GULF COAST UNDERGROUND SUBDIVISION

APPLICATION NUMBER 5 DATE February 3, 2021

APPLICANT Gulf Coast Underground Subdivision

DETAIL SITE PLAN

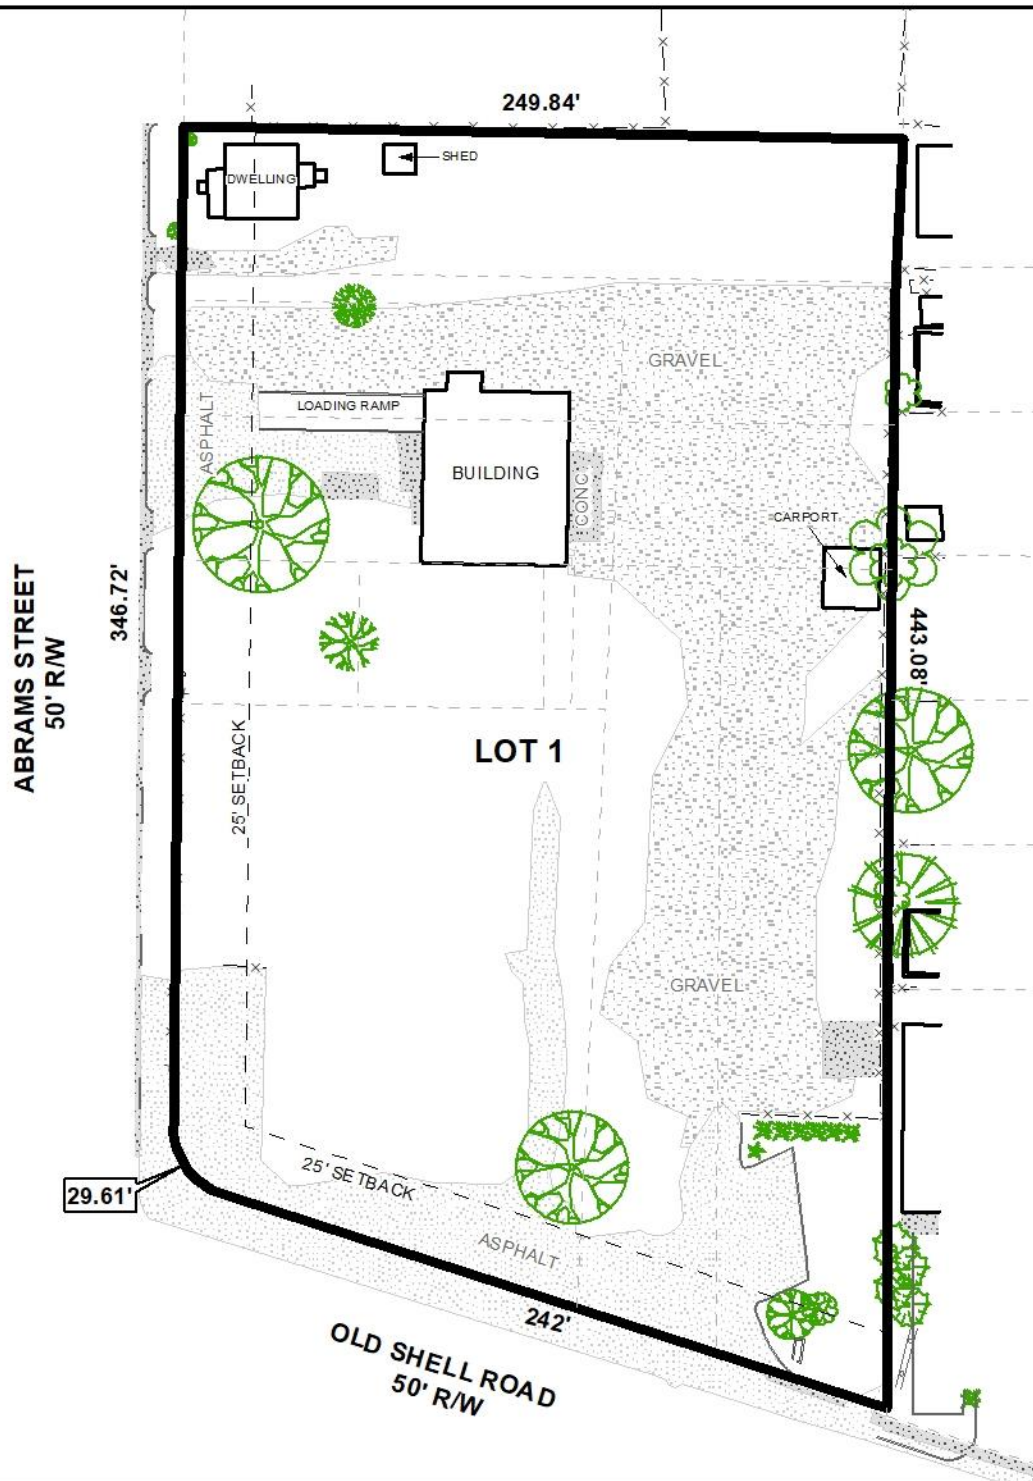
In accordance with the Subdivision Regulations, the proposed Lot 1 exceeds the minimum lot size requirement. If approved, the lot size labels in square feet and acres should be retained on the Final Plat or a table should be furnished on the Final Plat providing the same information.

As a corner lot, the proposed Lot 1 fronts Old Shell Road and Abrams Street, both minor streets at this location with intermittent curb and gutters. Each street requires a 50-foot right-of-way width. The preliminary plat illustrates sufficient rights-of-way along both street frontages; thus, no additional dedications should be required.

The preliminary plat does illustrate a compliant 25-foot minimum building setback line for Lot 1 along both Old Shell Road and Abrams Street and should be retained on the Final Plat. As a means of access management, a note containing the Traffic Engineering comments should be placed on the Final Plat.

It is important to note that any new development of the site will be required to fully comply with current zoning standards. There are multiple structures existing on the site. If approved, demolition permits should be obtained to leave a maximum of one building on the site, prior to signing the Final Plat.

- 1) retention of the 25-foot minimum building setback along Old Shell Road and Abrams Street;

- 2) retention of the lot size labels in both square feet and acres on the Final Plat or the furnishing of a table on the Final Plat providing the same information;

- 3) placement of a note on the Final Plat stating that no structure may be placed or constructed within any easement without permission from the easement holder, if applicable;

- 4) Obtain demolition permits so that no more than one building remains on site prior to signing the Final Plat;
- 5) compliance with the Engineering comments: (*FINAL PLAT COMMENTS (should be addressed prior to submitting the FINAL PLAT for acceptance and signature by the City Engineer): A. Provide all of the required information on the SUBDIVISION PLAT (i.e. signature blocks, signatures, certification statements, written legal description, required notes, legend, scale, bearings and distances) that is required by the current Alabama State Board of Licensure for Professional Engineers and Land Surveyors. B. Revise the written legal description and/or the bearing and distance label for the north line of the proposed subdivision. C. Provide the Surveyor's and Owner's (notarized) signatures. D. As shown on the 1984 aerial photo (FLIGHT 24 - #74) the LOT will receive 33,000 sf of historical credit of existing (1984) impervious area towards stormwater detention requirement per Mobile City Code, Chapter 17, Storm Water Management and Flood Control). E. Add a note that a Land Disturbance permit will be required for any land disturbing activity in accordance with Mobile City Code, Chapter 17, Storm Water Management and Flood Control); the City of Mobile, Alabama Flood Plain Management Plan (1984); and, the Rules For Erosion and Sedimentation Control and Storm Water Runoff Control. F. Add a note that the approval of all applicable federal, state, and local agencies (including all storm water runoff, wetland and floodplain requirements) will be required prior to the issuance of a Land Disturbance permit. G. Add a note that sidewalk is required to be constructed, and/or repaired, along the frontage of each lot, or parcel, at time of new development or construction, unless a sidewalk waiver is approved. H. Add a note that all existing and proposed detention facilities, common areas, and wetlands shall be the responsibility of the Property Owner(s), and not the responsibility of the City of Mobile. I. Add a note that all easements shall remain in effect until vacated through the proper Vacation process. J. Email a pdf copy of the FINAL SUBDIVISION PLAT and LETTER OF DECISION to the Permitting Engineering Dept. for review at land.disturbance@cityofmobile.org prior to obtaining any signatures. No signatures are required on the drawing. K. After addressing all of the FINAL SUBDIVISION PLAT review comments provide the ORIGINAL (with all signatures except for the Planning Commission, Traffic Engineering, and City Engineer), one (1) copy, and a transmittal letter to the Engineering Permitting Department. They can be dropped off at 205 Government St. or mailed to PO Box 1827, Mobile, AL, 36633.*);
